# **Landmark Commission**

**May 15th, 2019  
1ST FLOOR CONFERENCE ROOM  
4:30 P.M.  
AGENDA**

## APPLICATION FOR COMPREHENSIVE EXTERIOR RENOVATIONS TO 125 & 131 E WATER STREET

Reference Number: LC-03-19

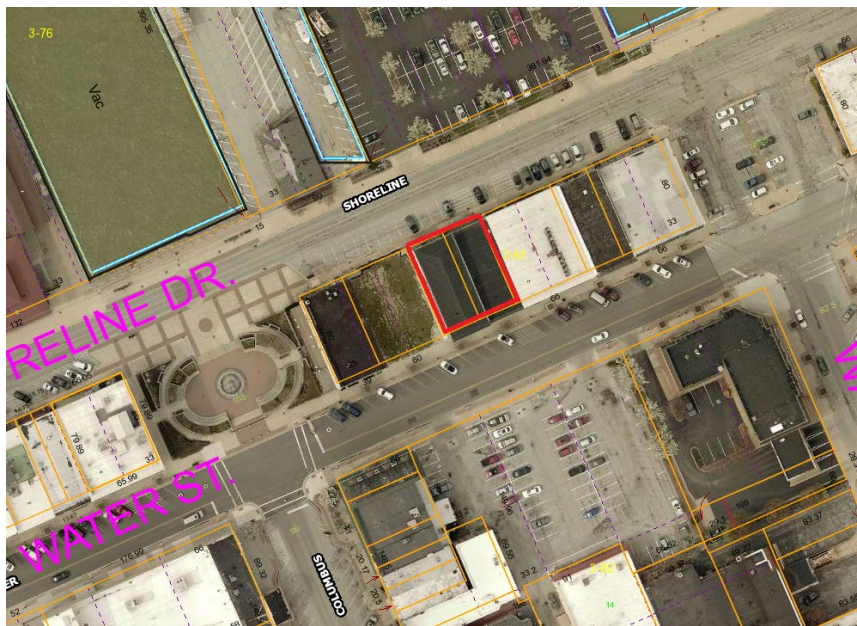
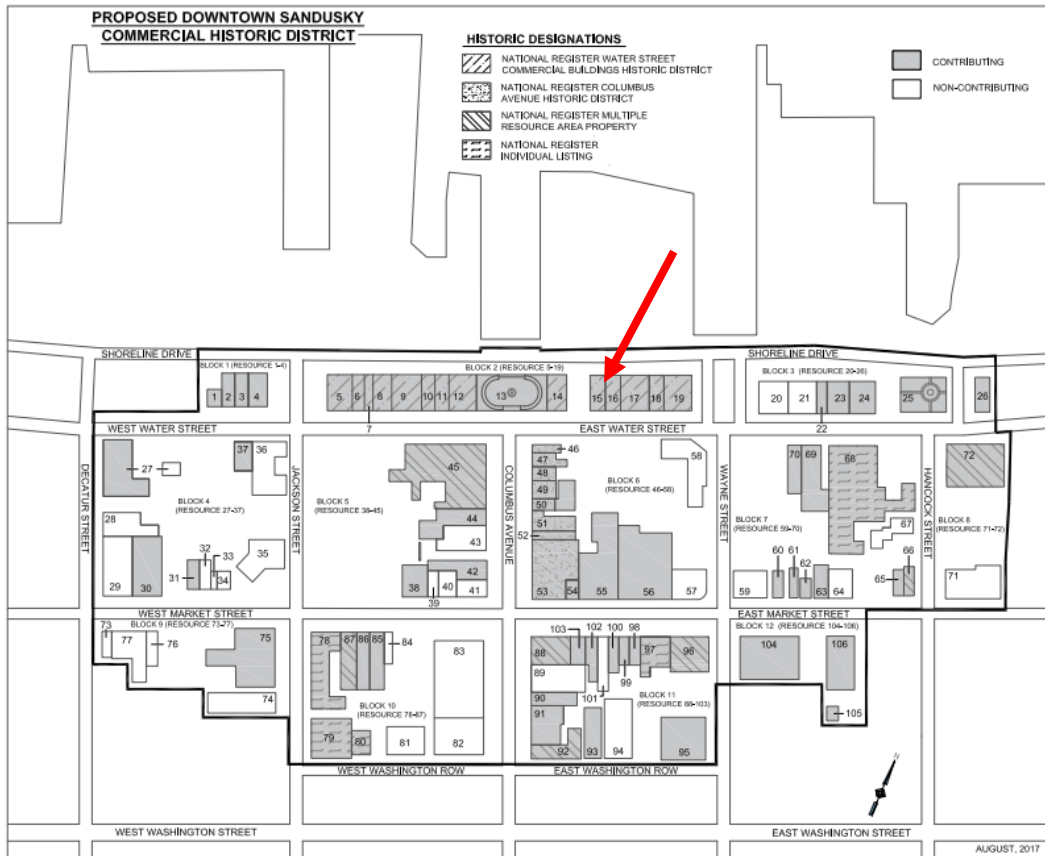
- The new door on 131 – Is there a reason that the door does not match the existing double doorway?
- Clarification on the materials of the windows on the north wall of 125.
- The material and color of the railing in the front entrance of 125
- The colors for the railings and doors on the exterior of the penthouse level
- The dimensions of the setbacks for the penthouse and rooftop deck.
- Concerns about the four curb cuts on Shoreline Drive. The Design Guidelines state that curb cuts should be minimized. This is especially true for Shoreline Drive, which is currently

being reconstructed to be more pedestrian friendly. Staff asked the applicant to work with his engineer to reduce the curb cuts and proposed a mountable curb sidewalk to maintain comfortable pedestrian flow

- 1) Per guideline to reduce curb cuts in the Sandusky Preservation Design Guidelines, & with the recent investment in the reconstruction of Shoreline Drive, staff recommends that the curb cuts be eliminated and that the garage access points be reduced from four down to one.—with a maximum width of 10 feet. The north exterior stairwell must be oriented sideways so that its protrusion into the right-of-way is minimized.

- 2) The access to the garage not be via a curb cut, but a drive via a mountable curb over the sidewalk that should minimize the obstruction of the sidewalk. It should match the design and color of the new Shoreline Drive streetscape. A cross section shall be submitted to the Planning and Engineering Departments for approval.

- 3) The color of the penthouse addition on the 131 E. Water Building should more closely match colors on the respective facades.
- 4) The addition of a new door to the front of 131 E. Water should be a double door to match the existing door.
